54 Canal Street aka 9 Orchard Street

Amend the originally approved submission to include: restoration of domed spire to be GFRC & GFRP combination, increase approved roof deck height

(in compliance with ZR 74-711), modify approved balustrade design to incorporate code requirements regarding railing, add marquee at Orchard Street entrance, increasing dunnage height at roof

Historic Restoration and Preservation - Amendments

Jarmulowsky Bank Building Roof Plan - Amendments

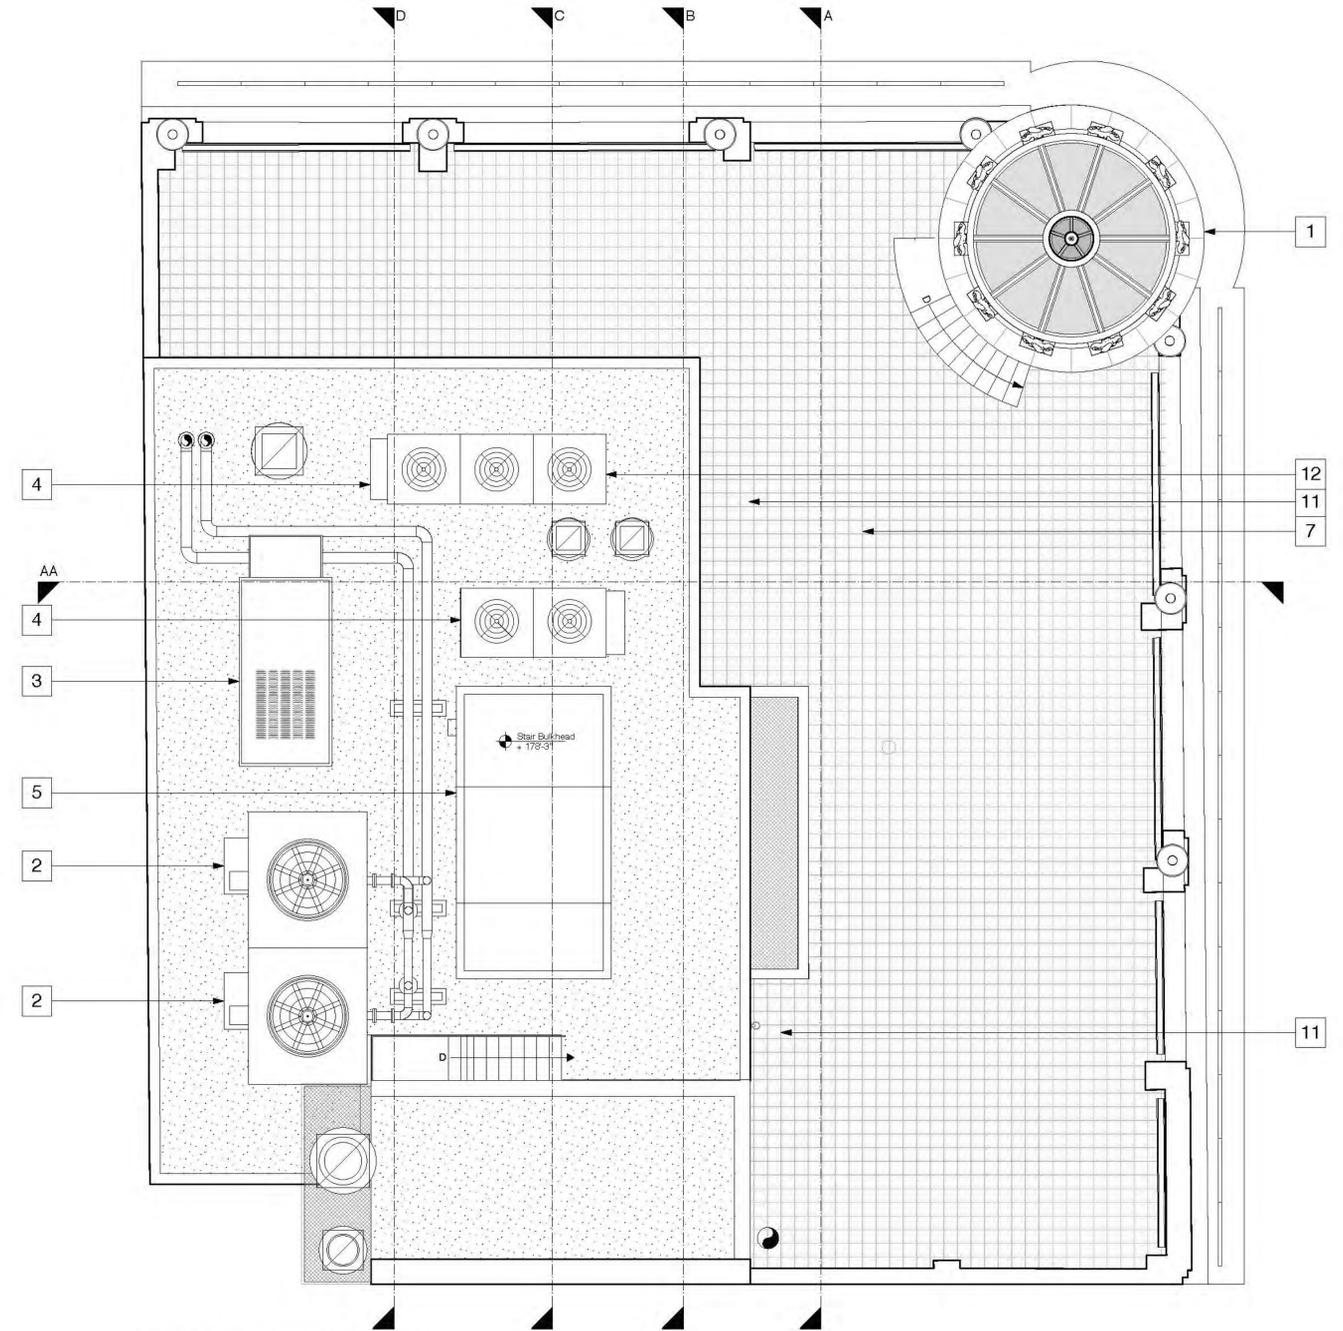
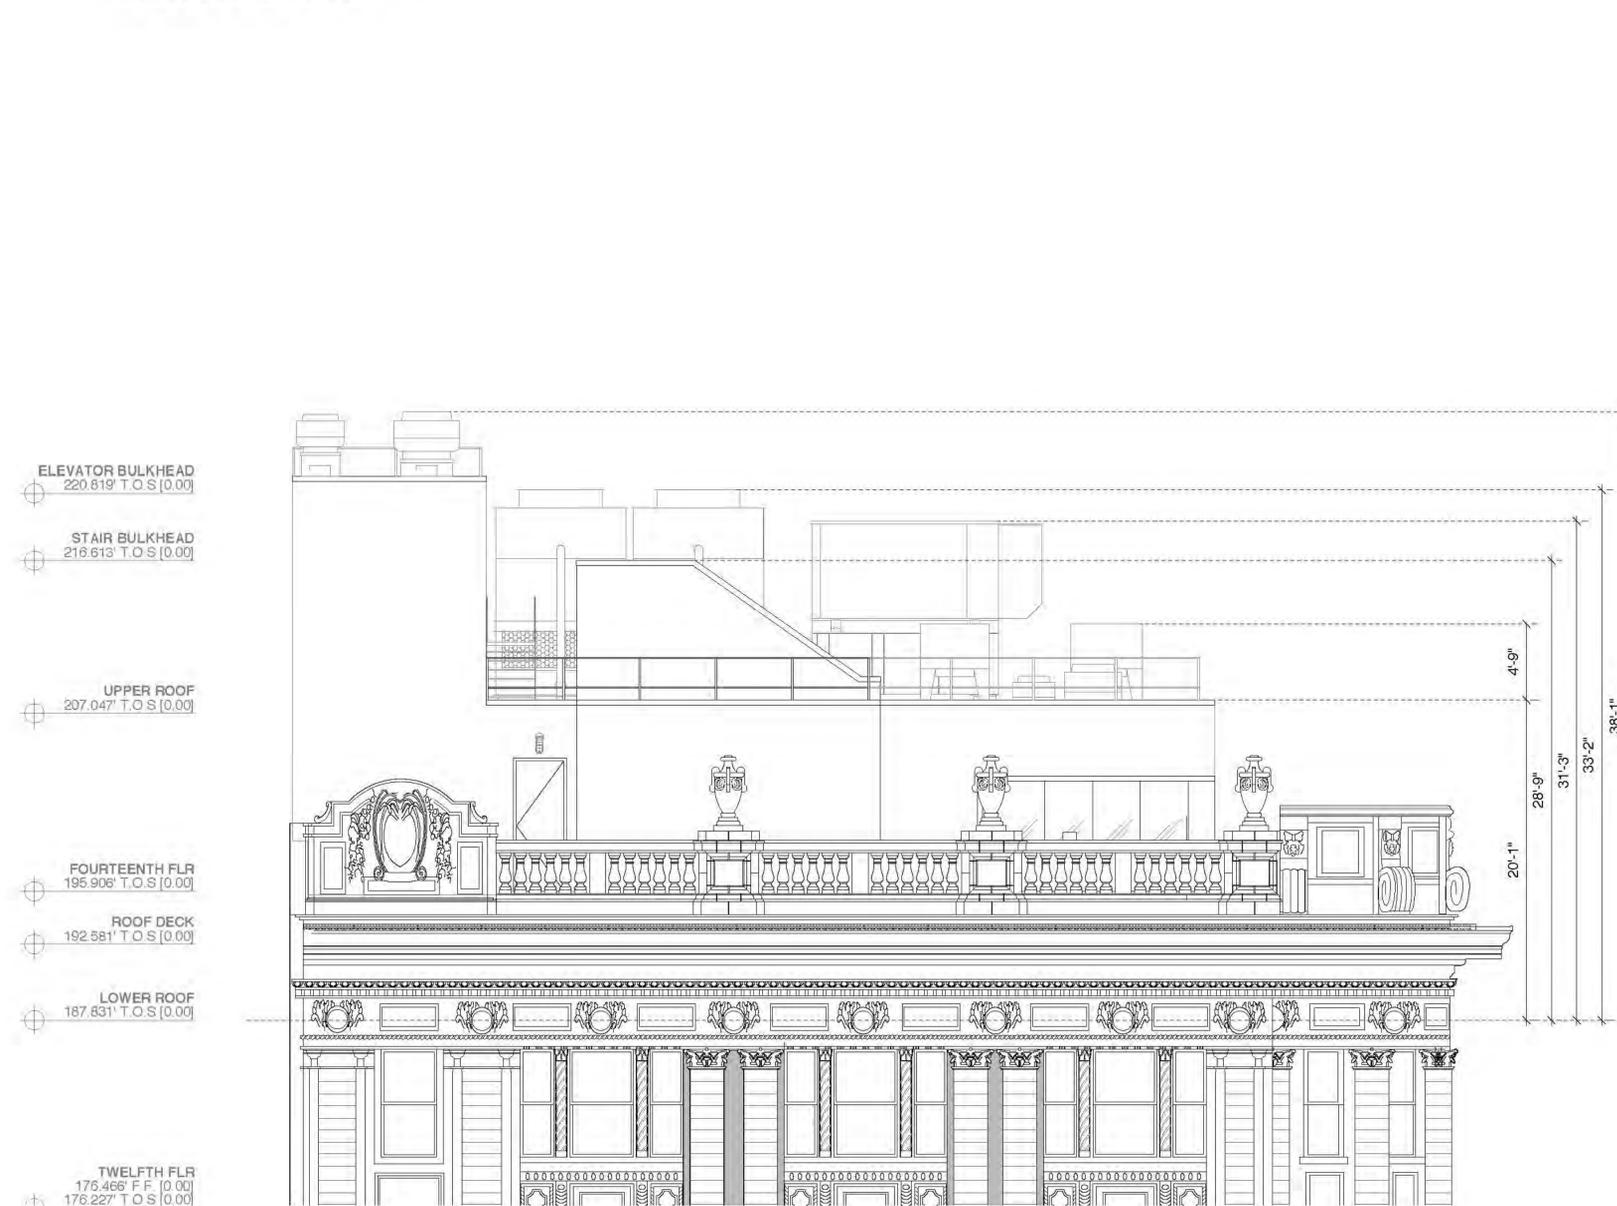
1. Proposed domed spire to match original historic domed spire. Details to be generated from original 1912 Rouse & Goldstone drawing obtained from Department Of Buildings and photographic documentation obtained from the New York Municipal Archives

2. Cooling towers on the roof have been raised approx. 10"
3. Emergency generator on the roof has been raised 10"
4. Liquid cooling fans on the roof have been raised 4"

5. Stair bulkhead has been flipped
6. Proposed marquee to be installed at Orchard Street entrance
7. Approved roof deck proposed to be raised an additional 3'-1" Pursuant to the zoning text ZR 74-711

8. Existing Windows to be converted to doorway openings to allow access to Roof Deck of New Construction at 60 Canal Street
9. Linear Troff Drains to be installed at the perimeter of the Roof Deck parallel to the existing parapet

10. Parapet raised to meet 42" minimum height above Roof Deck required by the 2008 New York City Building Code
11. Rooftop Staircase removed to correspond with amendment #7

12. Cooling Fans at Roof Re-arranged

East Roof Elevation - Amendments

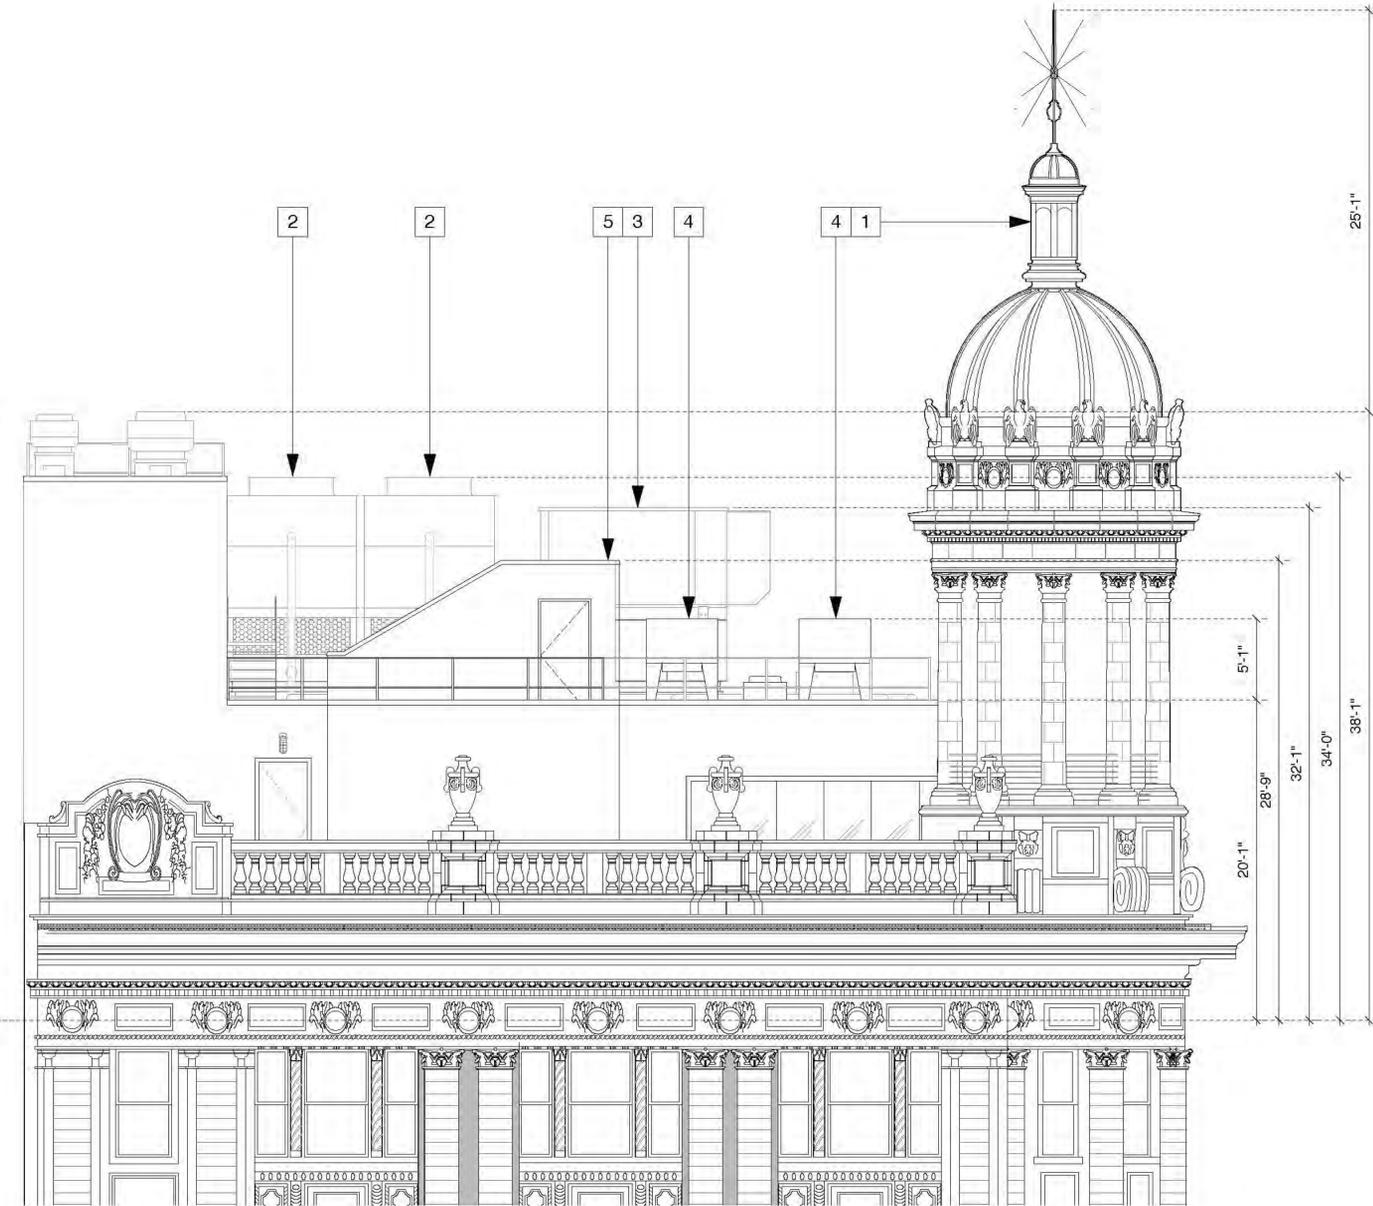
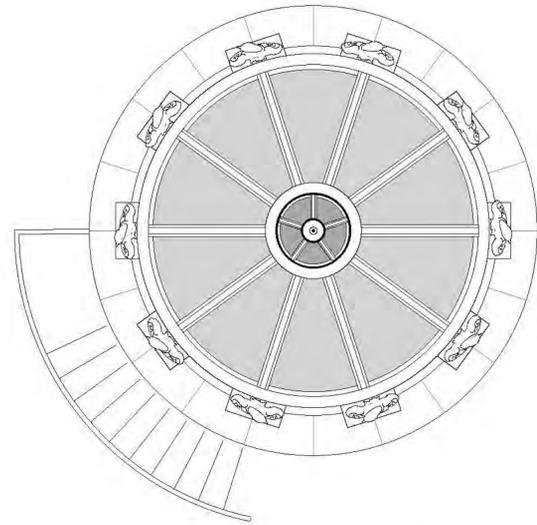
* note: All dimensions are taken from the existing roof T.O.S. unless other-wise specified 08 of 24

Jarmulowsky Bank Building Domed Spire Replacement - Details

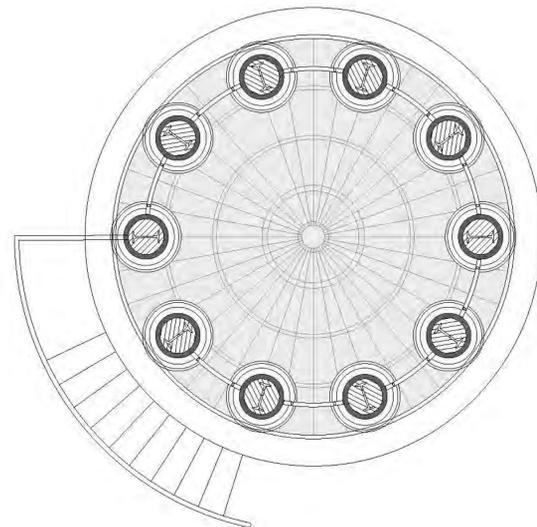
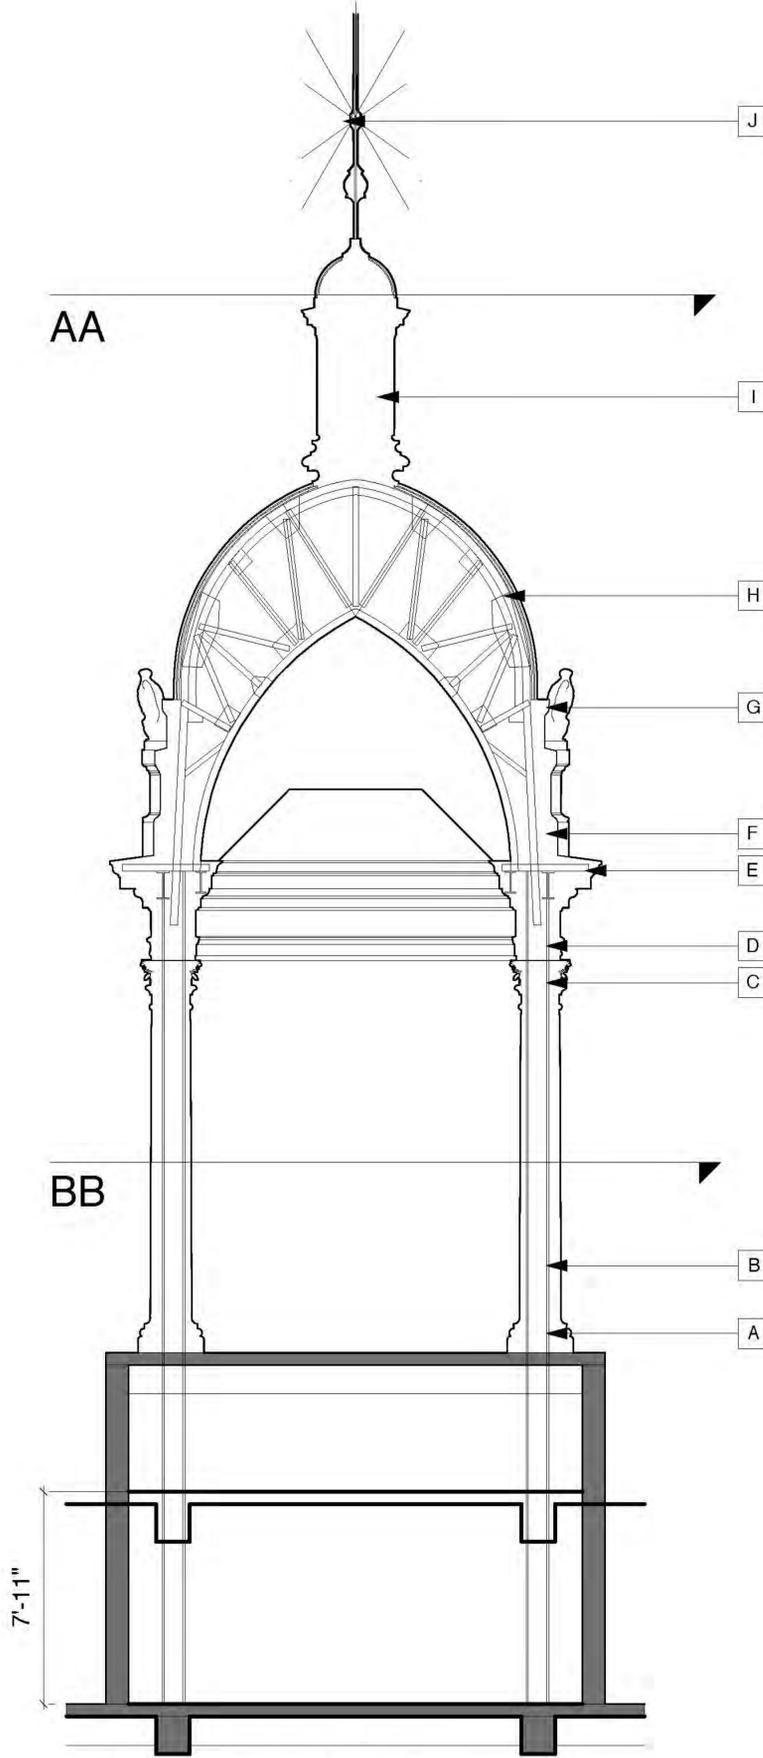
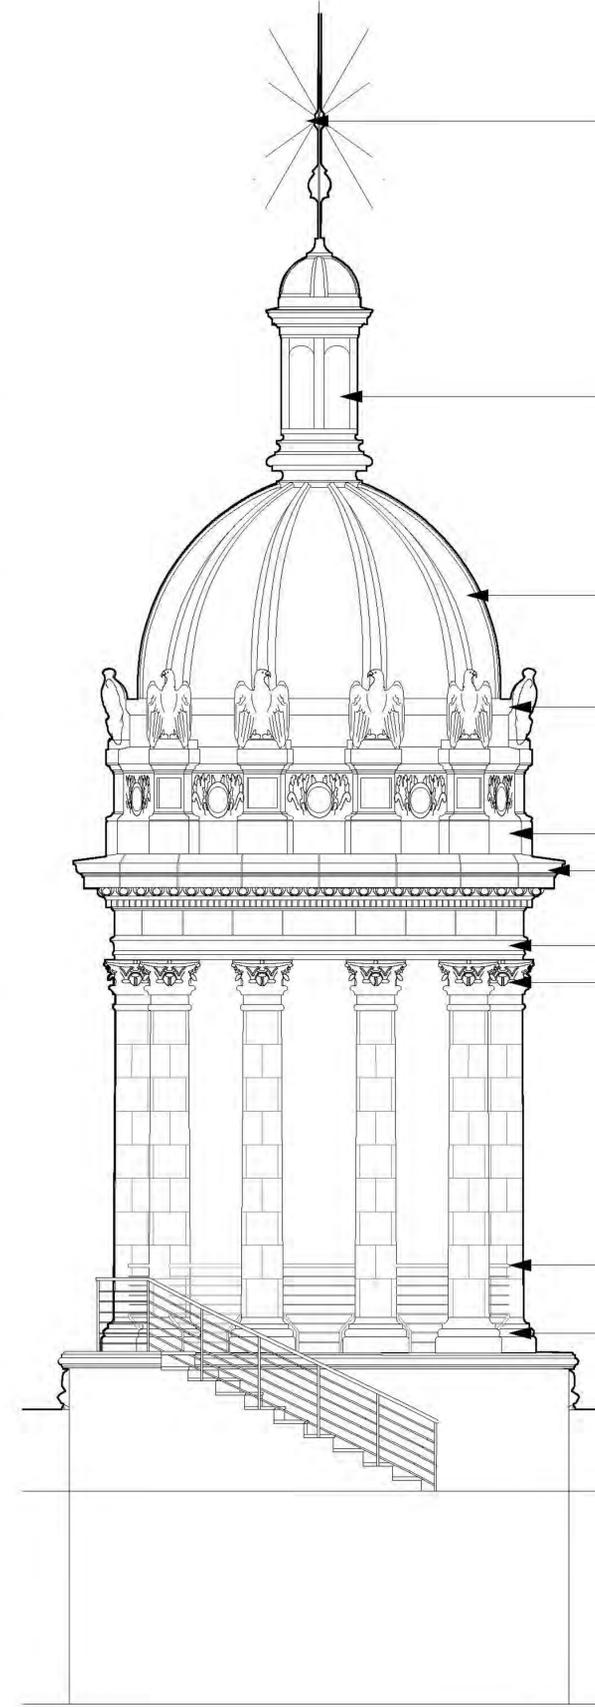
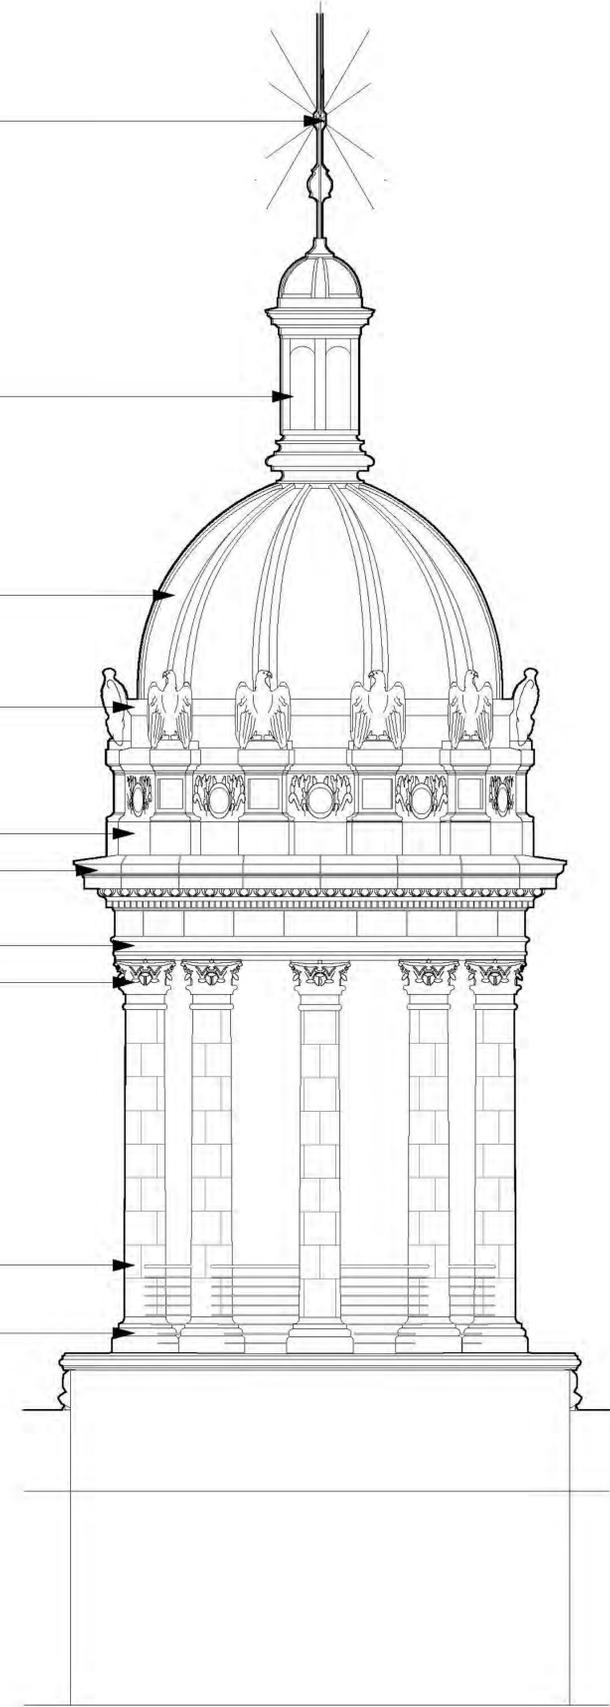
- A. Column base to be GFRC
- B. Column shaft to be GFRC
- C. Column capital to be GFRC
- D. Architrave to be GFRP
- E. Cornice to be GFRP
- F. Frieze to be GFRP
- G. Drum cornice to be GFRP
- H. Dome & ribbing to be GFRP
- I. Coupola to be GFRP
- J. Pinnacle to be GFRP
